City of Portland

Planning Board

Public Hearing

Tuesday, July 9, 1996, 7:00 p.m.

TRAFFIC ISLAND PLAN

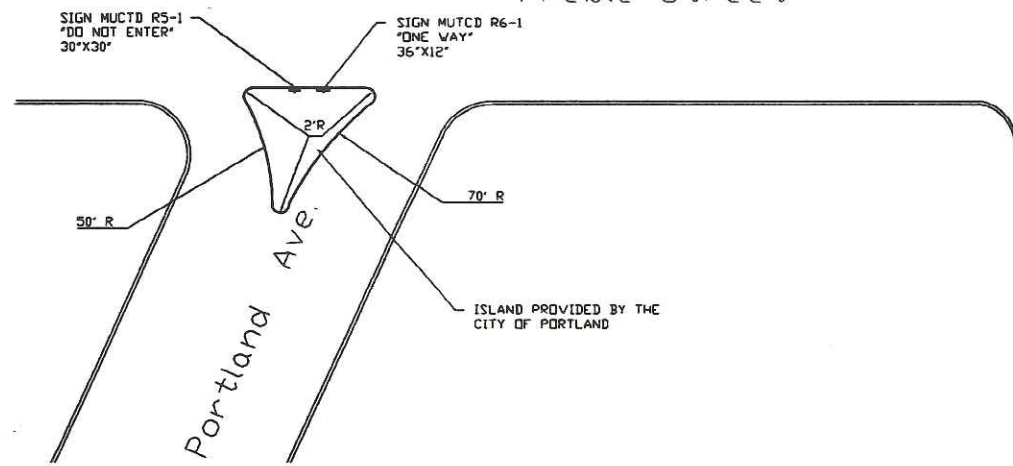
At your last workshop meeting, Bill Bray, the City Director of Public Works, was present to discuss traffic issues. And one of the things that was discussed, and it's not shown on one of these boards, is the need to have a delta island at Portland Street, at the intersection of Portland and Preble, because there was a concern that there would be conflicting traffic movement from Portland Street across Preble Street into the parking garage. The traffic report has been updated, and is shown in a traffic report. Since that time -- and I pass out a memo from Mr. Bray dated July 9, 1996 -- it was approved, this site, with respect to traffic concerns, but he would suggest a trial period for perhaps one year upon operation of the garage to serve whether actually the field conditions and use

of this parking garage would require that traffic island, and if it does, then the traffic island would need to be installed.

Site Improvement Plan

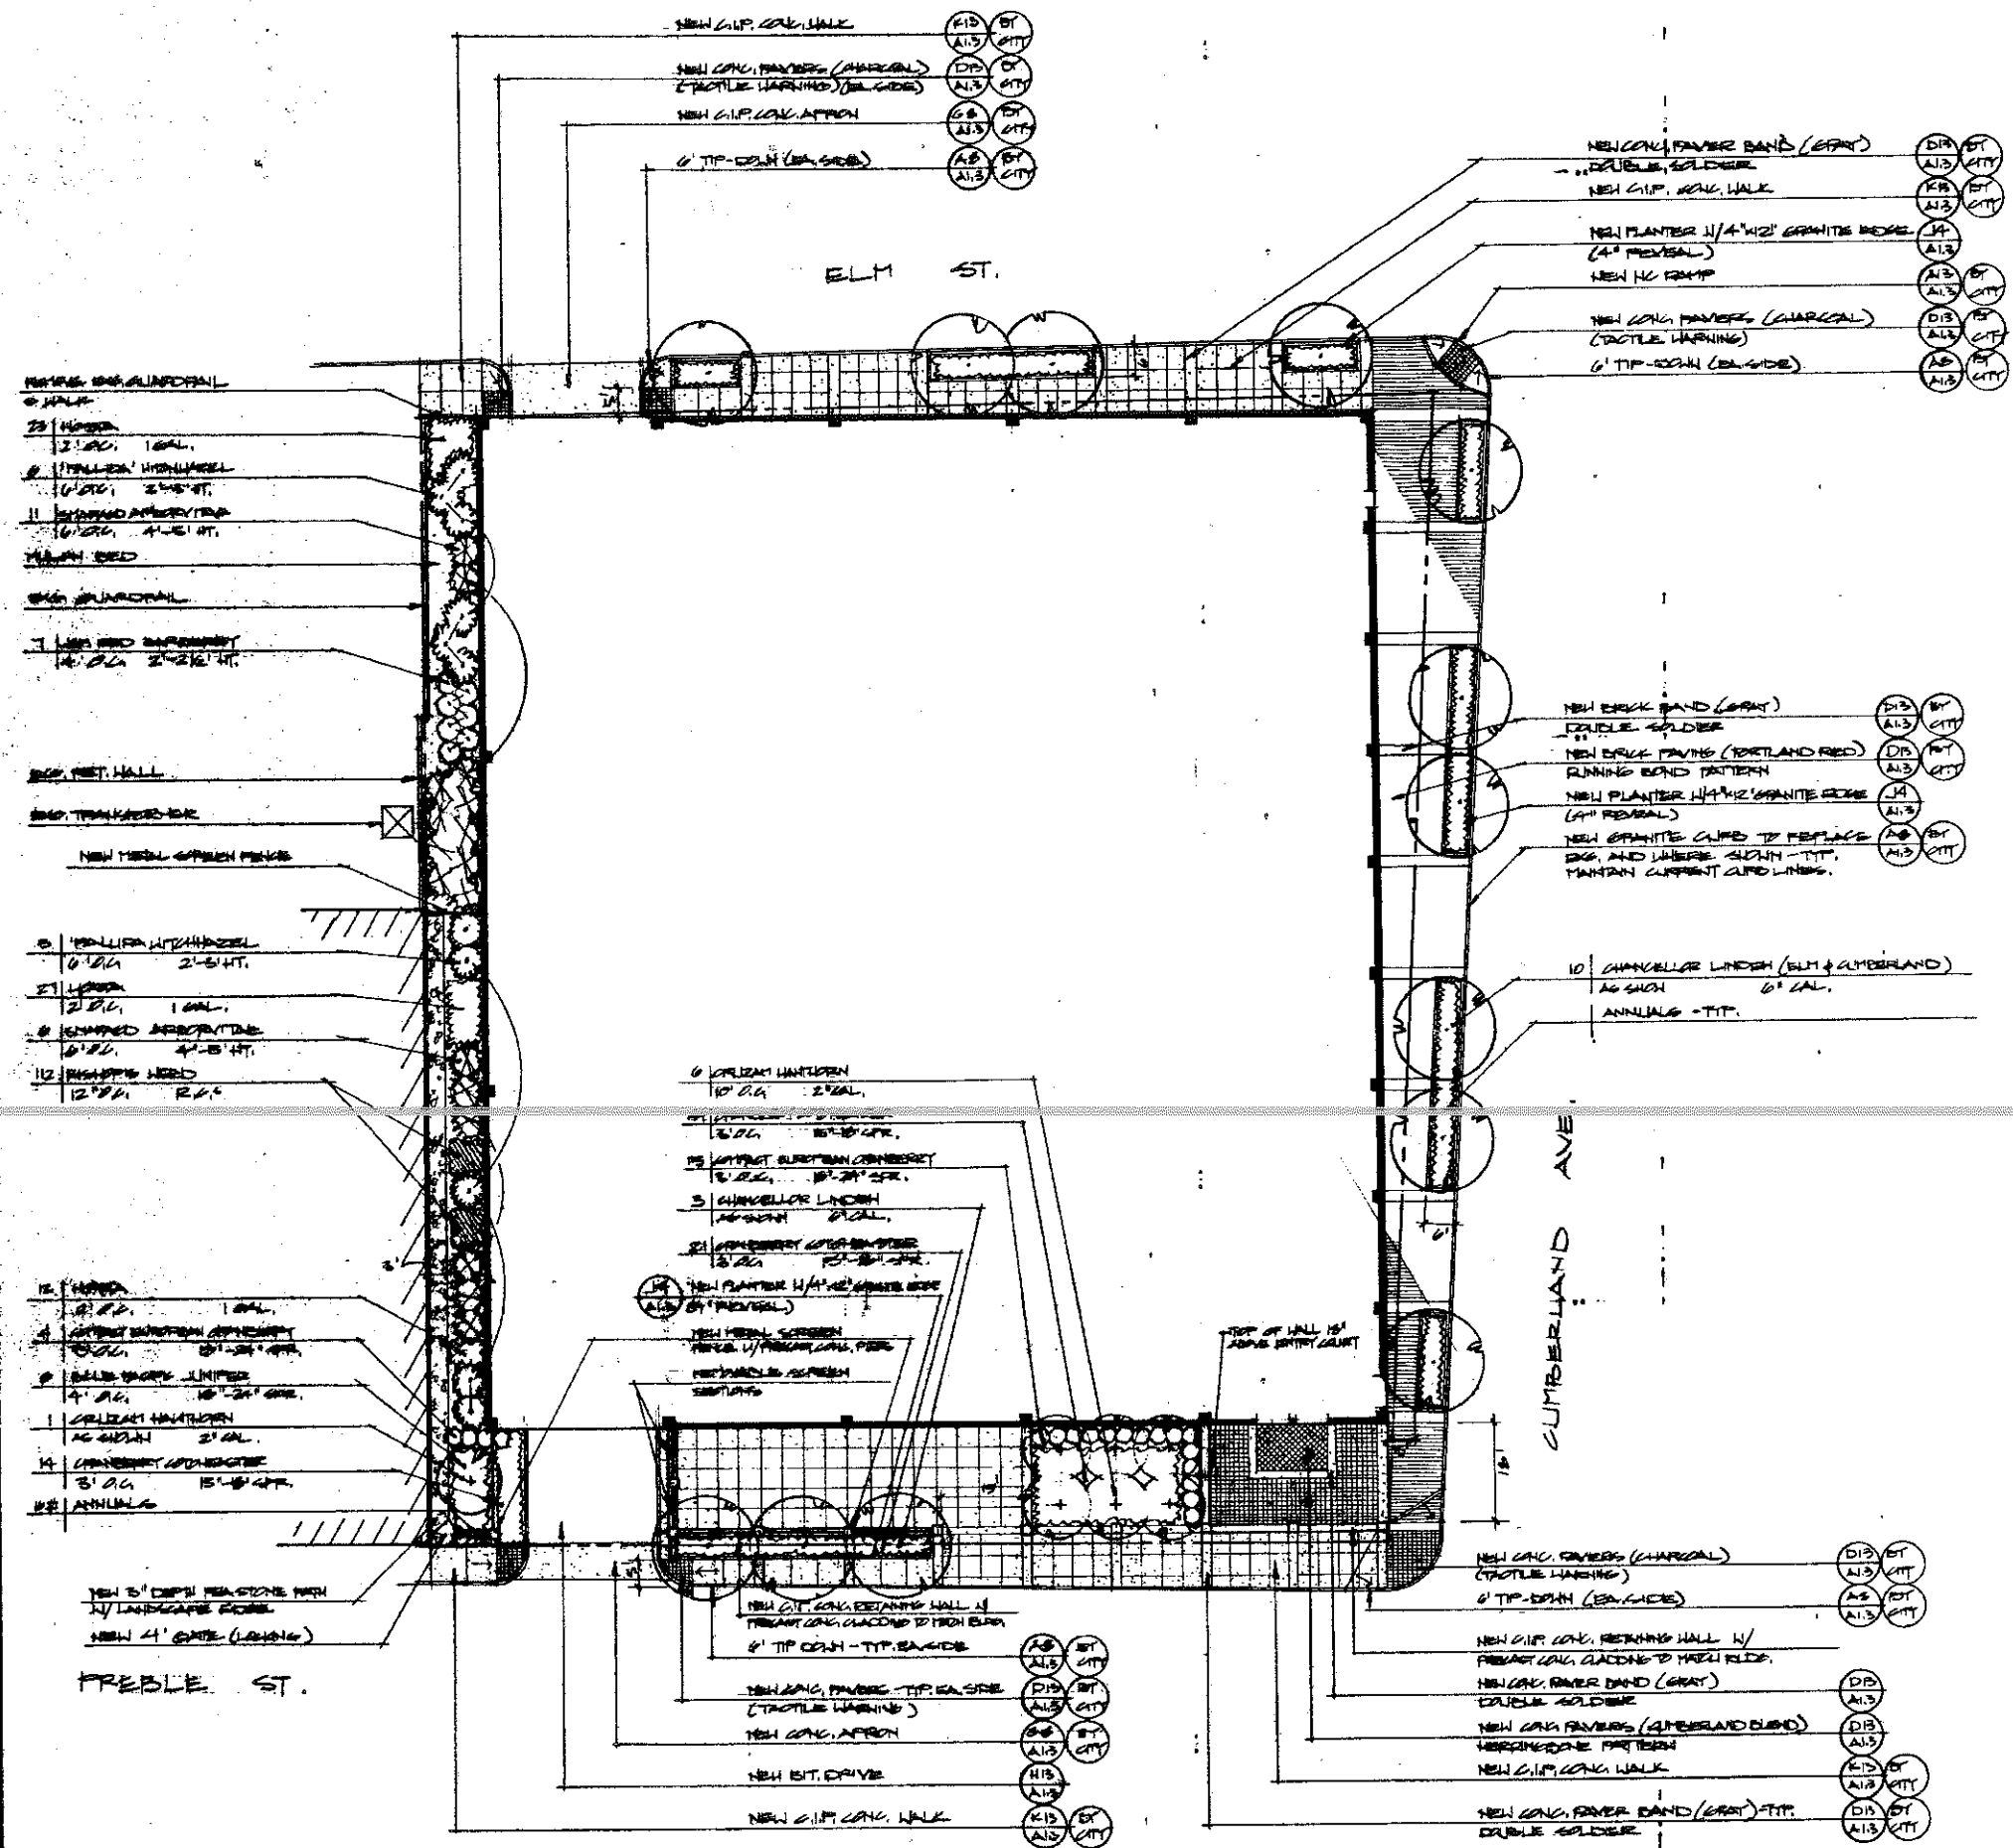
On Cumberland Avenue there is a setback of up to 10 feet from the property line, and the paving material for the said sidewalk is brick, with some paver

bands. Along Preble Street, the setback is approximately 24 feet and those paving materials will be again concrete, as well as with a paver band. In this case there was a requirement to abut an area on the side to store snow, and so this area in the corner will serve that function. Elm Street - concrete will be used as a sidewalk material, along with a continuation of some paver bands. The City will be responsible for the cost of curbing the sidewalk along all three sides of the project.

And one thing that I did skip over was the landscaping plan. Unfortunately, Jeff Tarling has been on vacation last week, and I was not able to get comments from him. Landscaping - there are six street trees shown along here, along Cumberland Avenue, in planters. There are three trees shown in front of the snow storage area, and a cluster of trees shown in this area over here. The site plan has since been updated, and I believe that there are some street trees here. Again, the quantity would seem to be appropriate, but we want to have the comments of the City Arborist. And the fourth revised facade detail that gives any of these

Preble Street Elevation

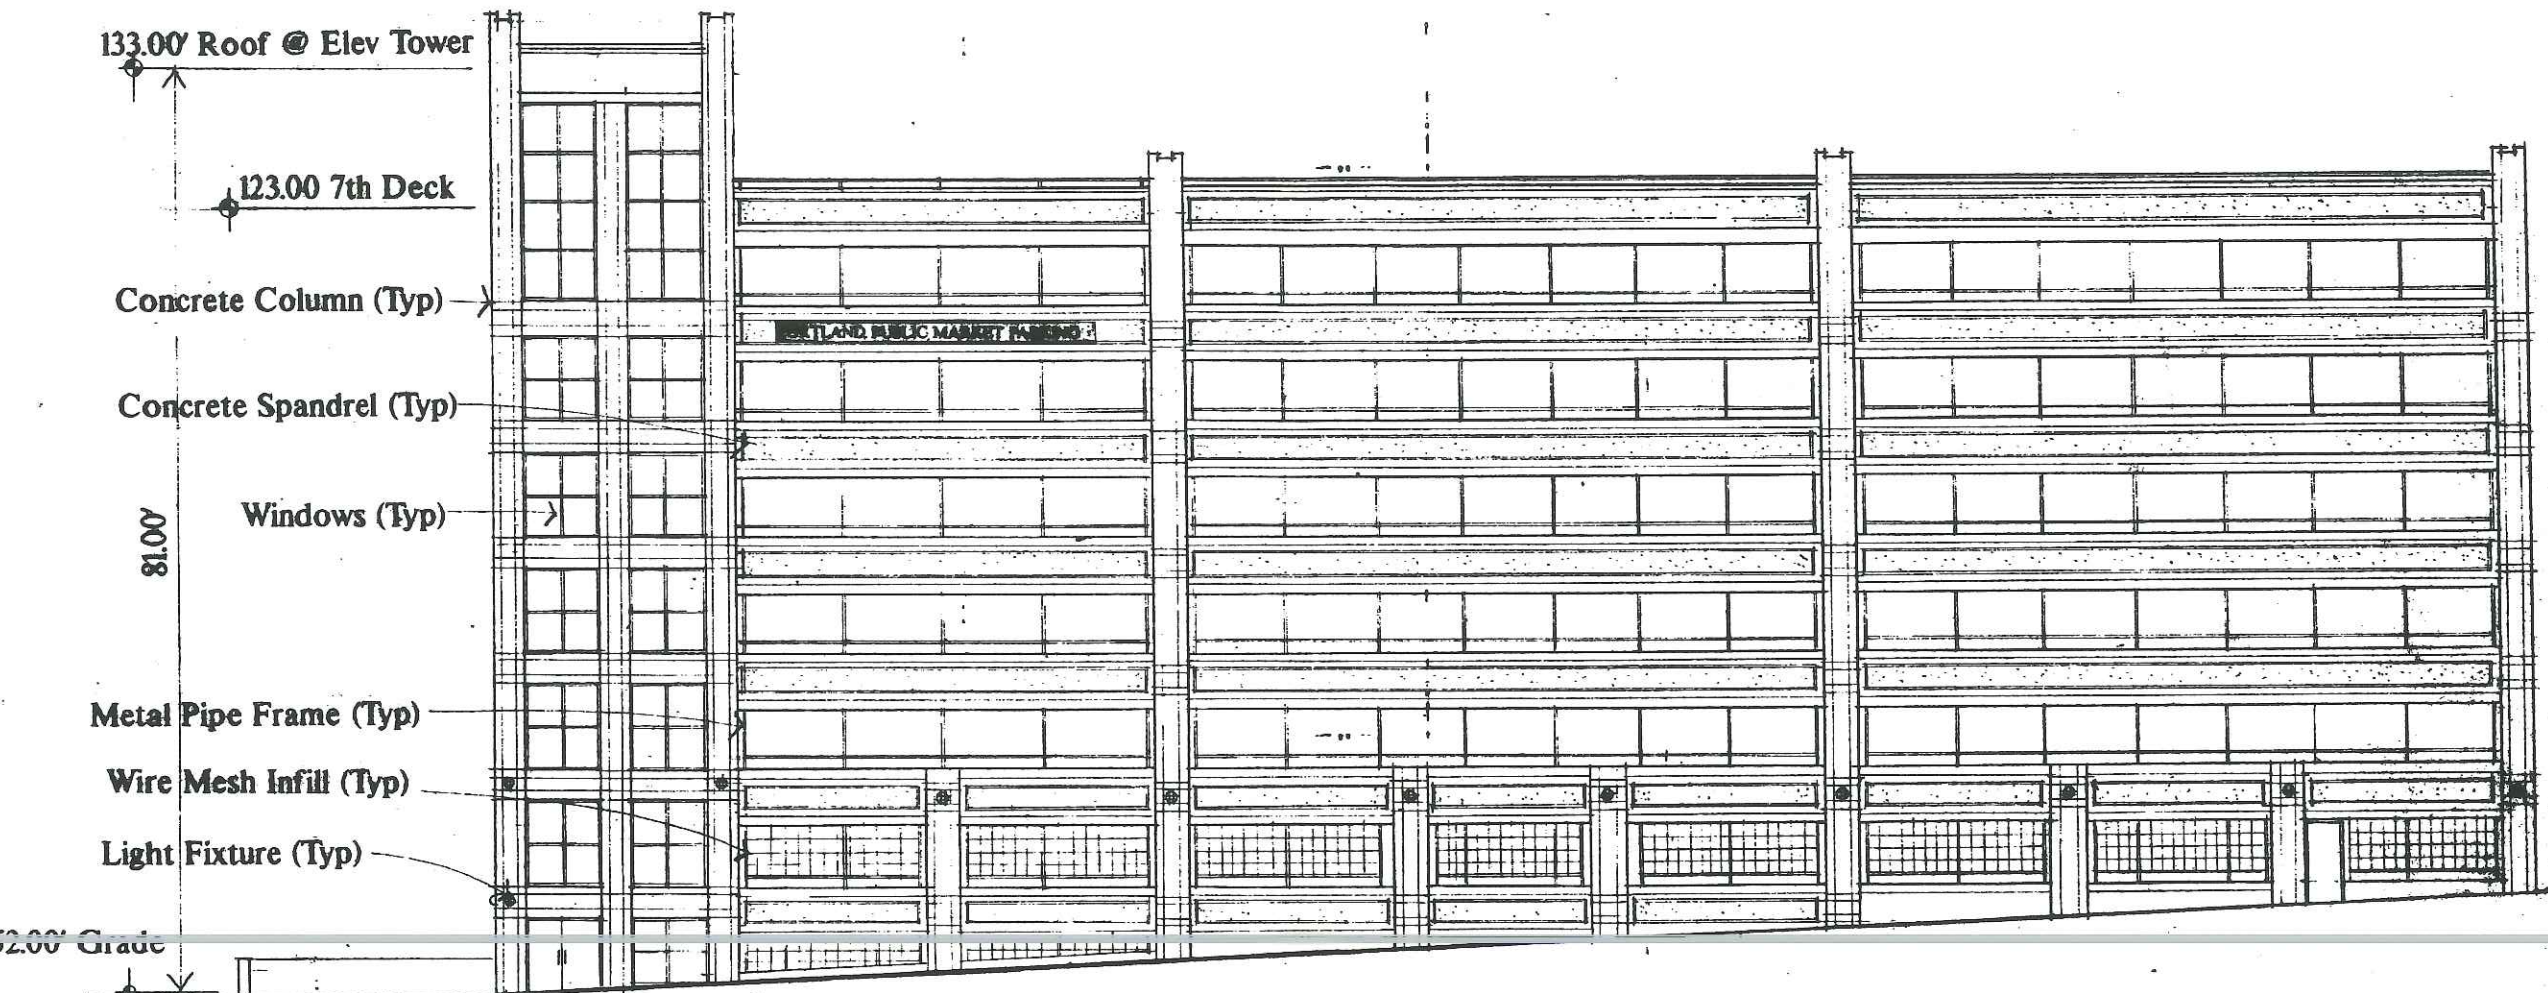
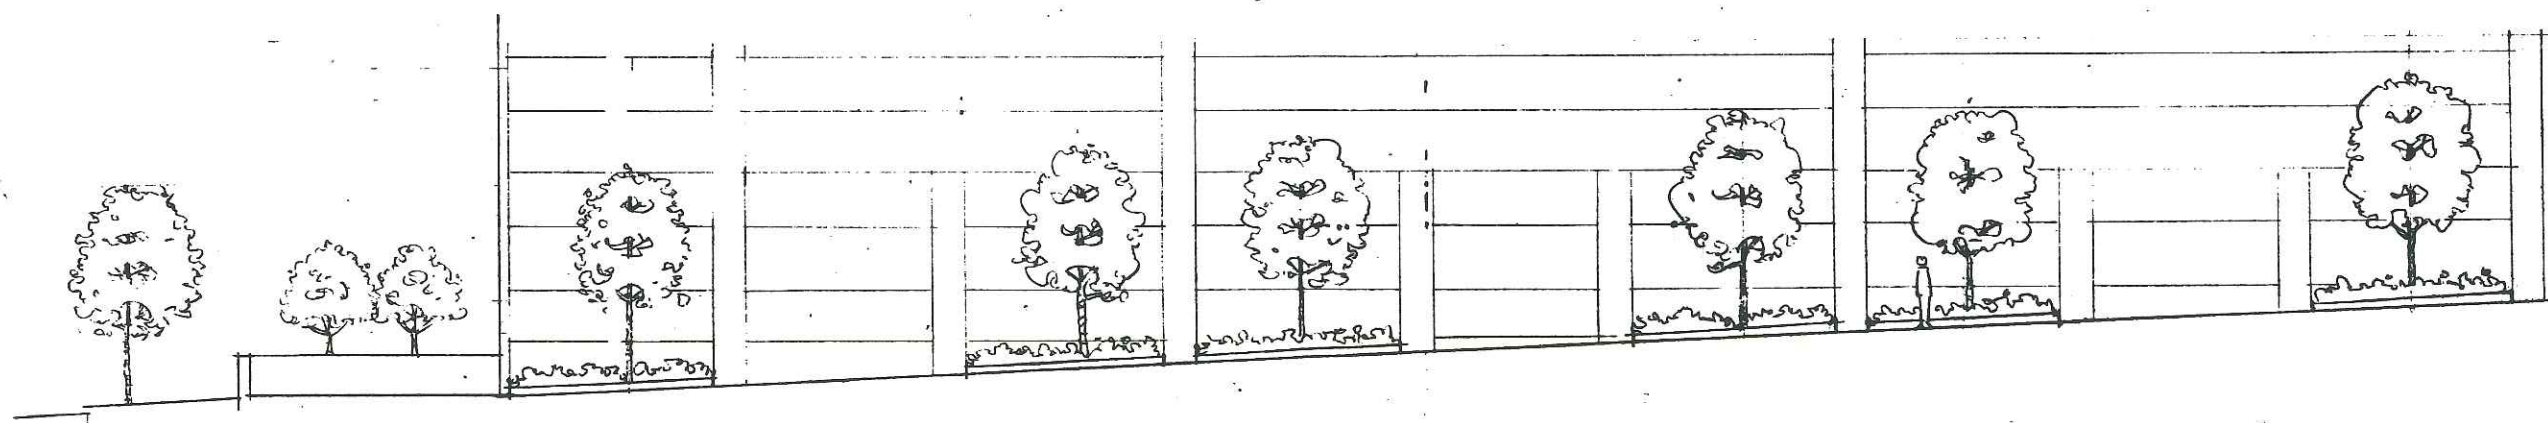
On page -- as we look at the exterior elevations of the building, a common feature of the site, and this is the Preble Street elevation, this is the Cumberland Avenue elevation over here, and this is the prospective -- along Preble Street. A prominent feature of the building, and really the anchor of the building, is a proposed elevator tower in the corner of Preble and Cumberland Avenue. The tower and its design provide a visual link to the Maine Bank & Trust Building, which is on Congress Street.

The basic facade itself will be constructed of pre-cast concrete, which is articulated by a series of horizontal and vertical joints that run along the pre-cast panels and columns. In addition, for security purposes, there is a grid. A metal grid system is proposed that goes along the first two ~~levels of the parking garage, and this treatment is~~ also proposed along Preble Street in front of the snow storage for the snow storage area.

On the bottom page of page 2 of the Staff Report and the top of page 3, we have outlined some Staff comments regarding the exterior elevation. The metal pipe frames that are shown in the elevation are in good position and provide some scale and rhythm to the large expanse of open areas between the concrete

panels. The color, however, is a dark green, which would seemingly make it disappear in the dark background, which would negate the use of this design feature. The exterior horizontal concrete panel, and that's labeled "concrete spandrel" in the elevations _____, basically these panels here, and the Board, I believe, was shown some samples at the last workshop. And there are four samples over there. One of the concerns that we had was that _____ is that it has an aggregate pebble stone surface. And although it does provide a contrast along the facade, perhaps there's a more appropriate treatment for that. One would be perhaps to use the smooth surface, which is the _____ for the main pre-cast concrete elements along the facade, perhaps some color could be added to the panels, or perhaps a lighter sandblasting treatment would be appropriate. We also suggest the use of tiles or medallions along the facade that could perhaps lighten up the facade a bit. Perhaps certain sections or architectural elements of the facade could be colored or painted. In a pedestrian environment, visual interest is always an important consideration. We reference the Jetport where certain architectural elements were painted, would seem to work out well in that specific context.
